Memorandum

Date: June 17, 2019
To: Mayor Vinis and City Council
From: Gabe Flock, Senior Planner
Subject: Summary of Planning Commission Recommendation for Downtown Riverfront

Planning Commission Recommended Revisions

Figure 9.3155(3)(g) S-DR Zone Height Standard "G"

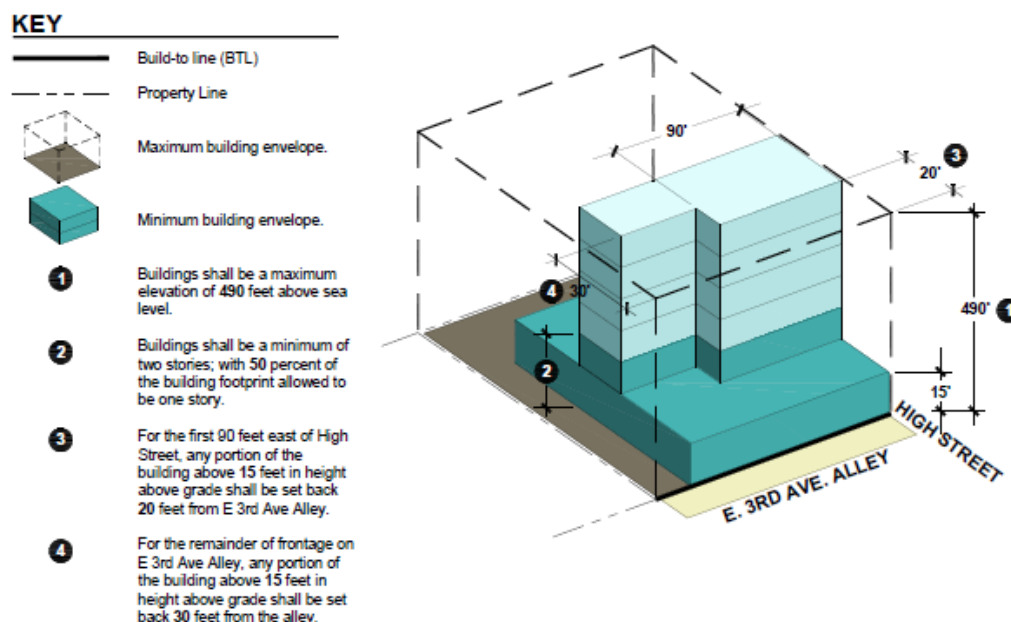
A) Planning Commission Recommends imposing new step-back and height requirements on a specific property located north of 4th Avenue by:

- Making changes to the draft code text at EC 9.3155(3) and (4), shown on page 146 of the City Council's June 24 packet (see highlight, below);
- Adding a new Figure EC 9.3155(3)(g) (see below); and
- Making revisions to add the new height standard "G" to Figure 9.3155(3) S-DR Zone Height Regulating Plan shown at page 152 of the City Council's June 24 packet (see below).

- (3) **Building Height.** Minimum and maximum building heights shall be determined using Figure EC 9.3155(23) S-DR Zone Height Regulating Plan and Figures EC 9.3155(3)(a) through (g). In the event of a conflict between the written text and the figures, the figures shall control. ***Notwithstanding the provisions in EC 9.6715 and EC 9.6720, trellises, structures providing weather protection, architectural features, and other devices may be erected no more than 12 feet above the height limits established in this land use code, whether such structure is attached to it or freestanding.***

- (4) **Building Stepbacks.** Required building step-backs in the S-DR Zone are shown on Figures EC 9.3155(3)(a) through (g) and on Figure 4-3 of the Downtown Riverfront Specific Area Plan. Step-backs are measured from the front of the building facing a primary street, **from the side of the building adjacent to an alley and or**, where applicable, from the side of the building when abutting the S-DR/CL subdistrict.

Figure 9.3155(3) S-DR Zone Height Regulating Plan

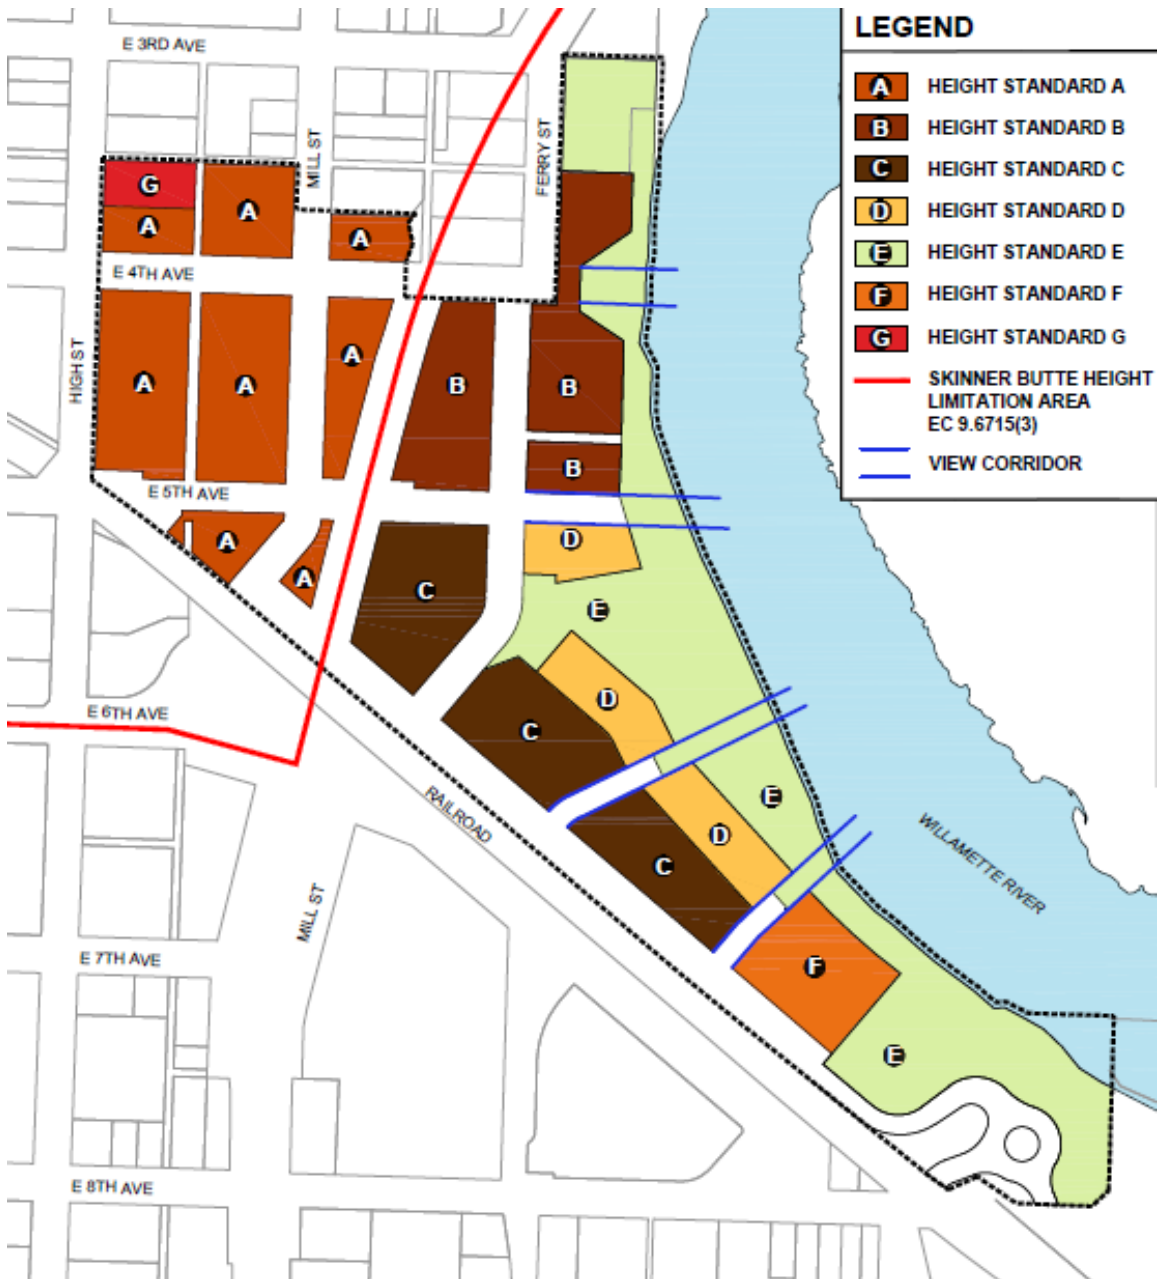
- D) To amend the draft Figure EC 9.3155(3) to extend the view corridor along 5th Street to its intersection with Ferry Street, and along the two southerly rights-of-way leading toward the new riverfront park (“Local Roads 1 and 2”) to their intersections with “Railroad Boulevard.” The intent of this recommended change is to clarify and extend the restrictions against obstructing the view corridors to the river, while also amending the draft code to clarify that building projections such as balconies and other features defined in 9.3155(6), *are* allowed in view corridors.

- o Making changes to the draft code text at EC 9.3155(15) shown on page 148 of the City Council's June 24 packet (see highlight, below); and
- o Making revisions to extend the view corridor boundaries on Figure 9.3155(3) S-DR Zone Height Regulating Plan shown at page 152 of the City Council's June 24 packet (see Figure 9.3155(3), above).
